**DTB**

Date: October 27, 2008  
 Order No.: S-B-13.22/01e  
 Supersedes: S-B-13.22/01d dated July 10, 2008  
 Group: 13

**SUBJECT: All Passenger and Light Truck Models**  
**Equipped with Engine M272 Up to Engine Number 272xxx 30 476520**  
**Equipped with Engine M273 Up to Engine Number 273xxx 30 085890**  
**Noise Coming From Front of Engine**

Figure 2

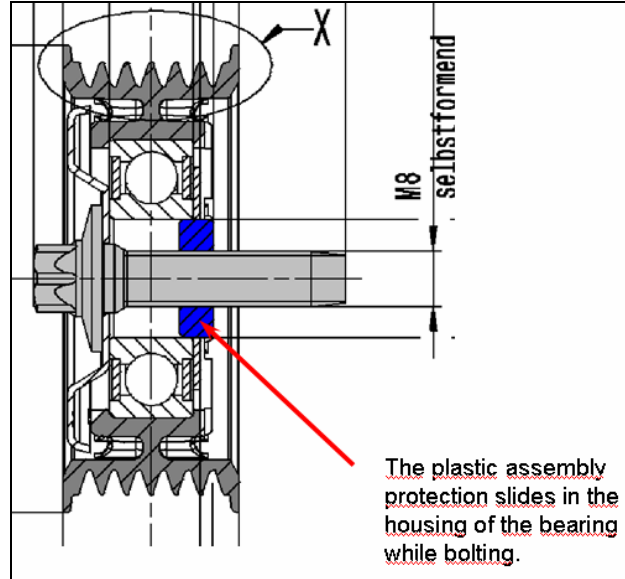
**i** **Note: Revised instruction:** It is **not** necessary to remove the spacer before installation. The black plastic retainer will assist in centering the flat spacer washer and pulley on the mounting lug (Figure 2).
